# KITTERY TOWN PLANNING BOARD MEETING

**AGENDA for Thursday, May 14, 2015**

**Town of Kittery  
 Planning Board Meeting  
 May 14, 2015**

**Bartlett Hill Multifamily Cluster Subdivision – Subdivision Preliminary Plan Review**

SHEET C6 OF C6

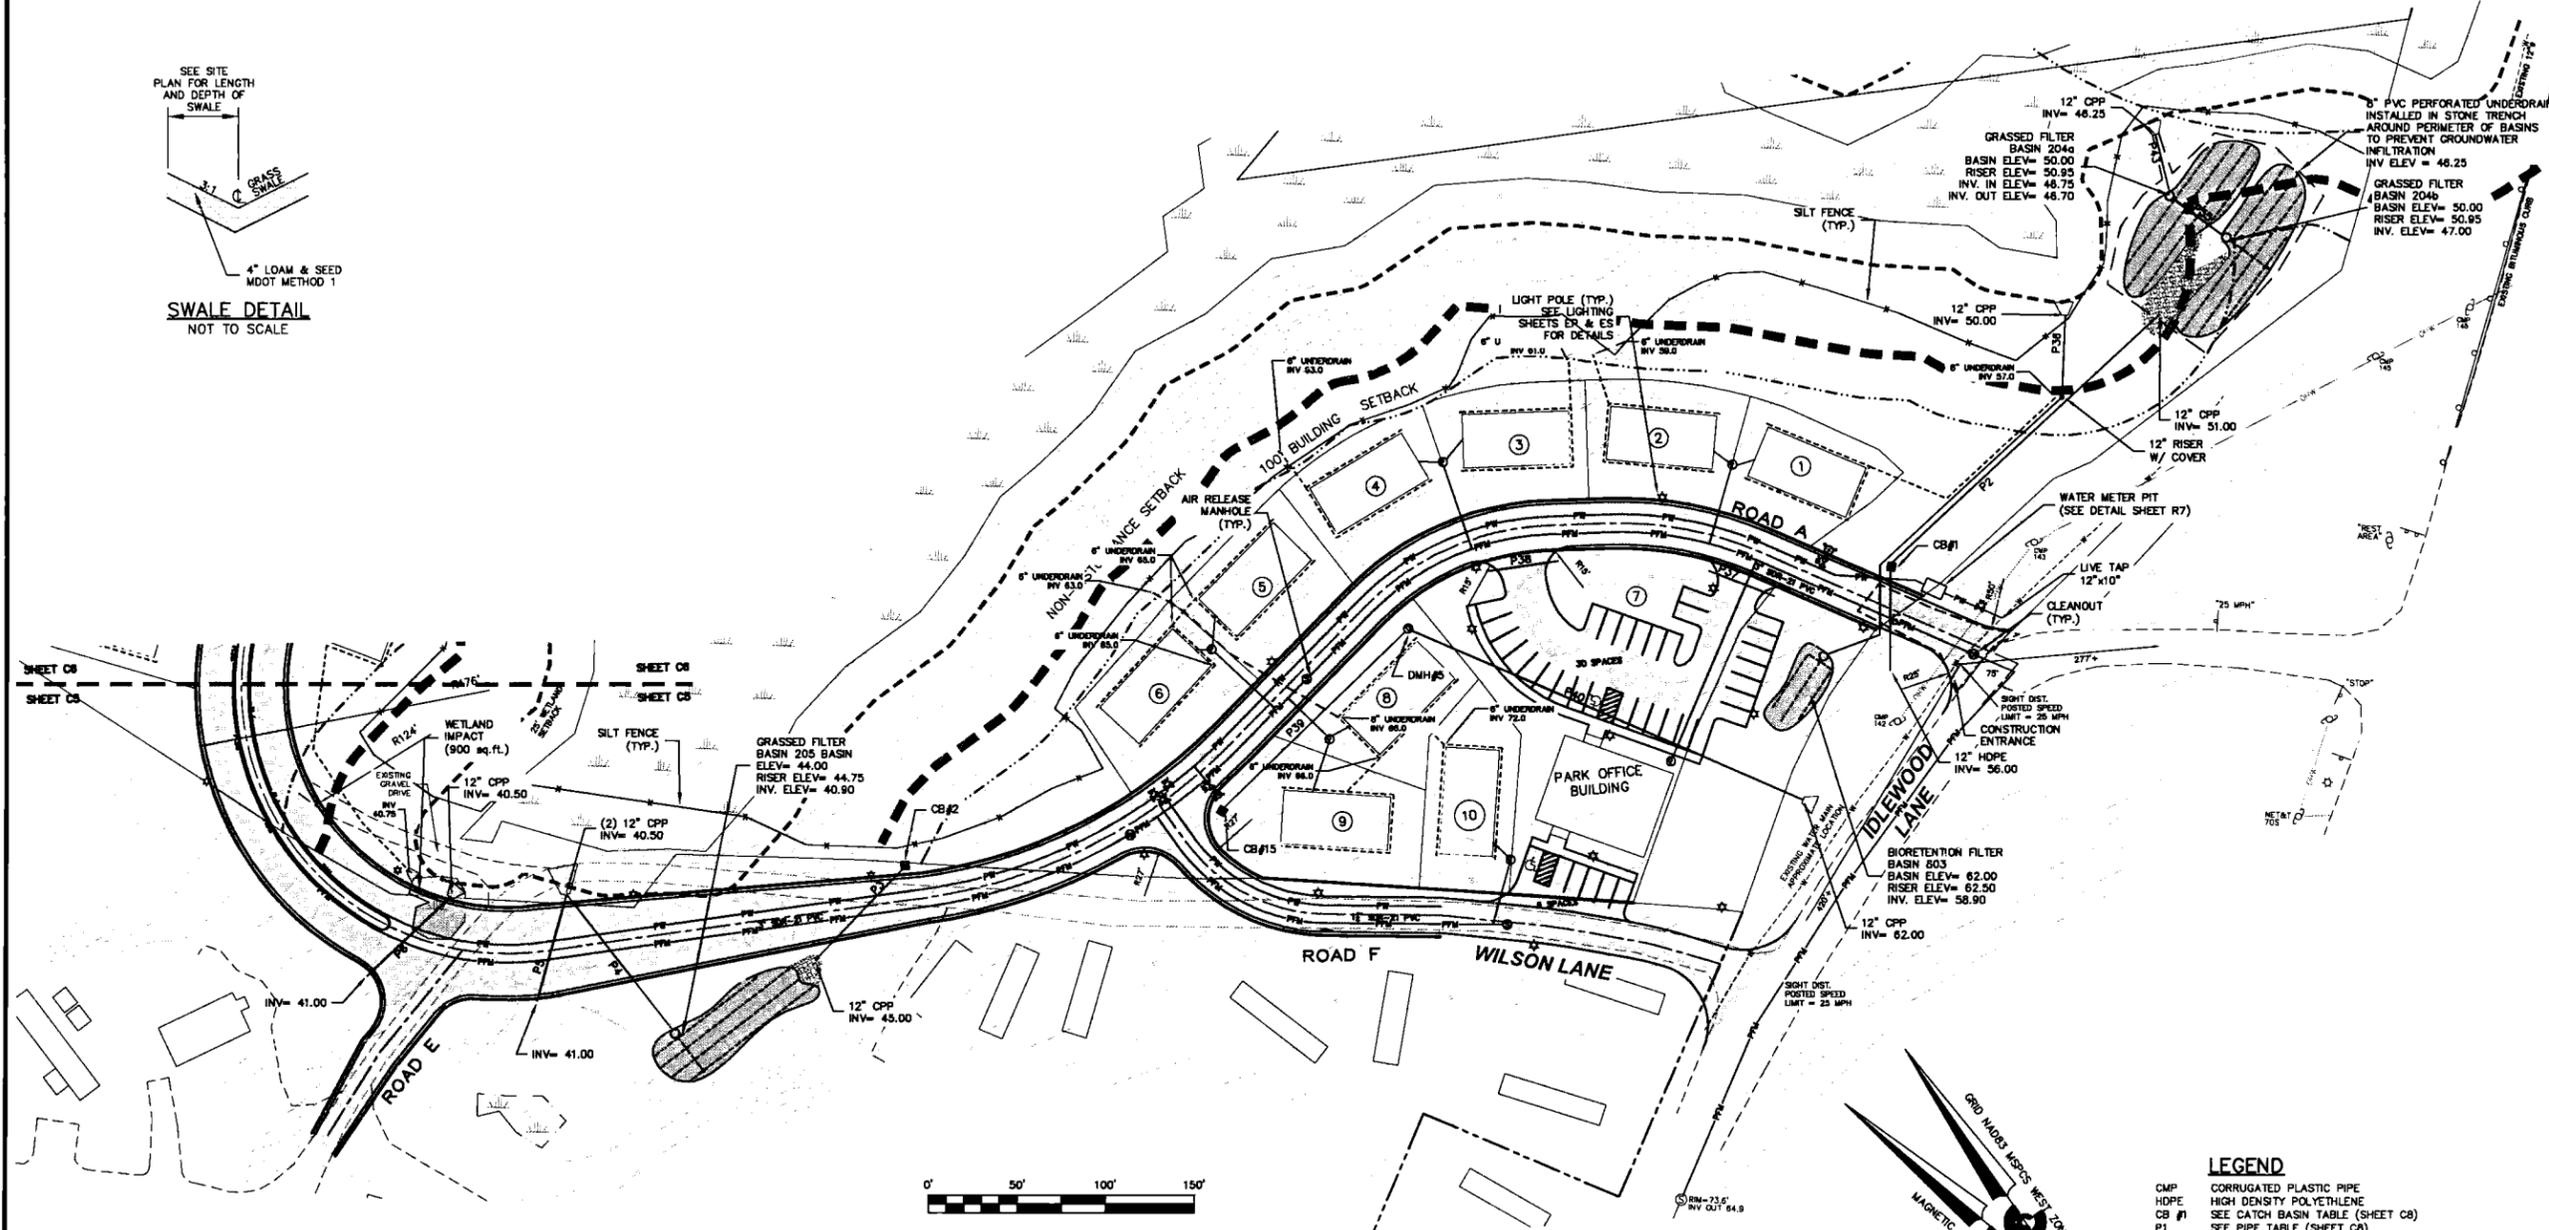
*There are four instances where there are encroachments within the required buffer (See Sheet C6): Building 3 & 4 driveway and associated grading; level spreader behind Building 4; force main south of Building 9; and the terminus of the cul-de-sac and associated grading. The Board may want to consider waiving full compliance due to unique site constraints and, in the case of the cul-de-sac, the area has already been disturbed.*

UPDATE: The revised plan appears to have removed encroachments to the no-cut/no-disturb buffer area.
